NRC INFORMATION NOTICE NO. 89-29: POTENTIAL FAILURE OF ASEA BROWN BOVERI
CIRCUIT BREAKERS DURING SEISMIC EVENT

Subject: Slow Close Lever Rebound Spring for
ABB Power Distribution K-Line
Electrically Operated K-225 through
K-2000 Circuit Breakers
(Part 21 Report)

FIELD INSTALLATION OF: Slow Close Lever Rebound Spring
Electrically Operated K-225 through
K-2000 Circuit Breakers.

FIGURE 1

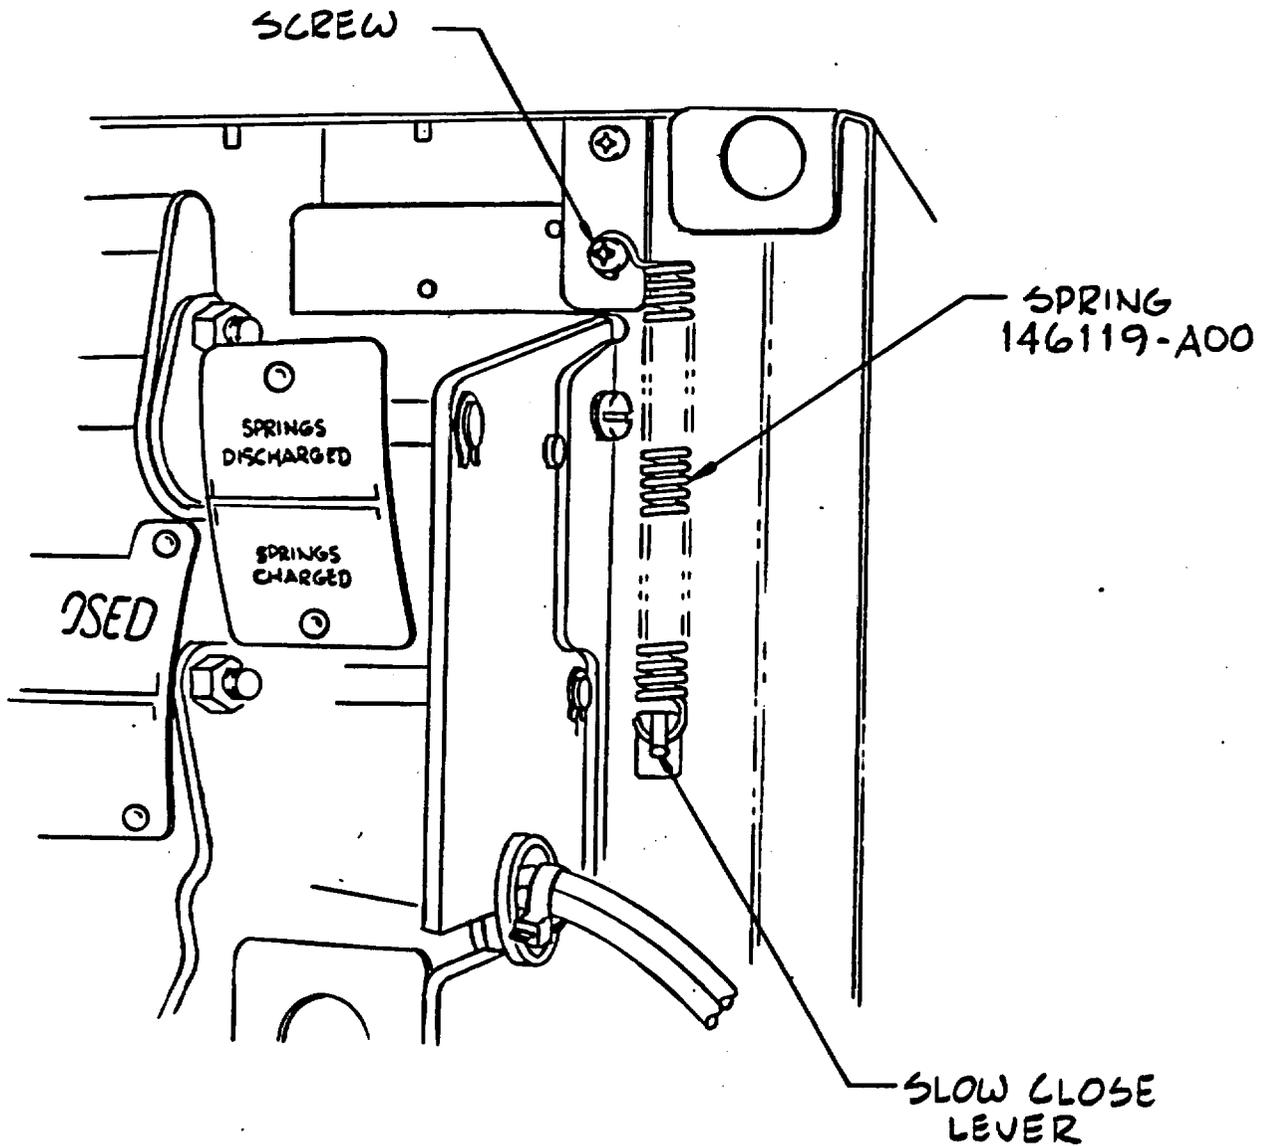
5. Locate also the upper right Phillips pan head screw which attaches the black housing to the silver-grey front frame. Loosen this screw approximately two turns. See Figure 1.

6. Hook on end of spring 146119A00 over the loosened screw. Stretch the spring so that the hook can be slid down on the slow close lever.
7. Retighten the screw to secure the spring at its top. This completes the spring installation.
